# Eagle Mine Permit to Install

## *Public Comments on Eagle Mine (No. 50-06D)*

**April 3, 2020**

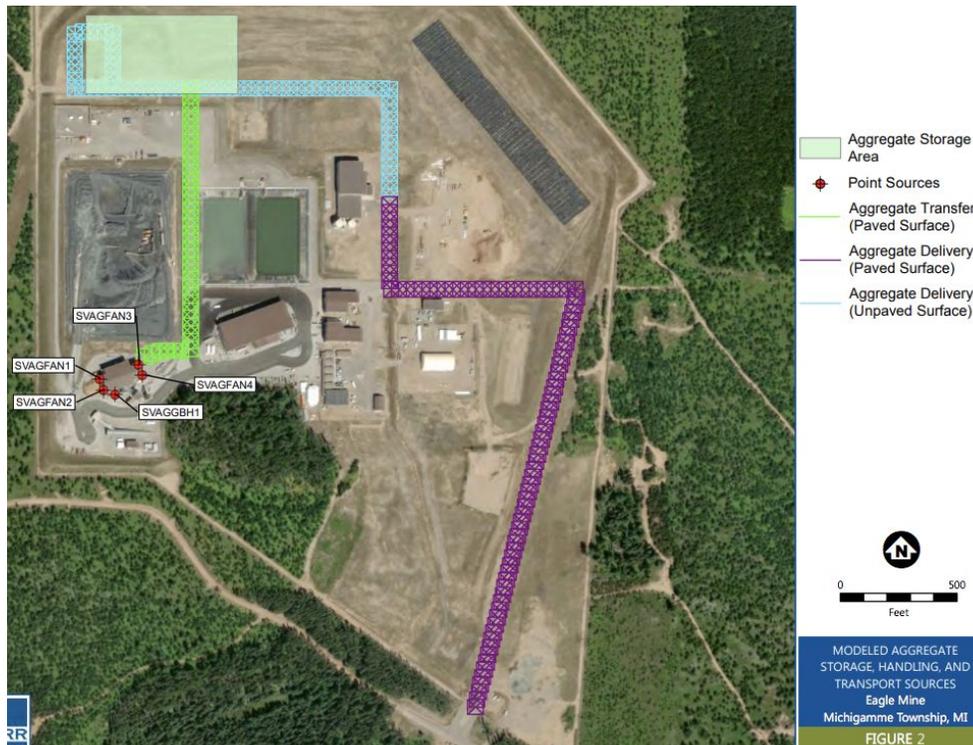
Modeling of emissions has been essentially unverified, as the mining company has been operating on the basis of one premature and unrepresentative stack-testing event done in September 2014.

- We request continuous air quality monitoring (portable unit or other) for PM, Copper and Nickel. Monitoring points are needed at the mine site (Eagle Rock) and at the nearby Main Vent Air Raise site.
- The nearest monitoring site has been Big Bay, 9.5 miles northeast of mine site (straight-line distance). We request that additional monitoring sites should be set up between Big Bay and the mine.
- **What are Eagle Mine’s data for Nickel, Copper and PM emissions, as required by the 2013 Permit to Install 50-06B?** We believe that the permittee has not verified their operational “PM, NICKEL, AND COPPER EMISSIONS” for the Main Vent Air Raise as required by their 2013 PTI. Now that Eagle East ore will soon be mined, we expect that emissions will be increased— Eagle East ore is higher grade for Nickel and Copper.
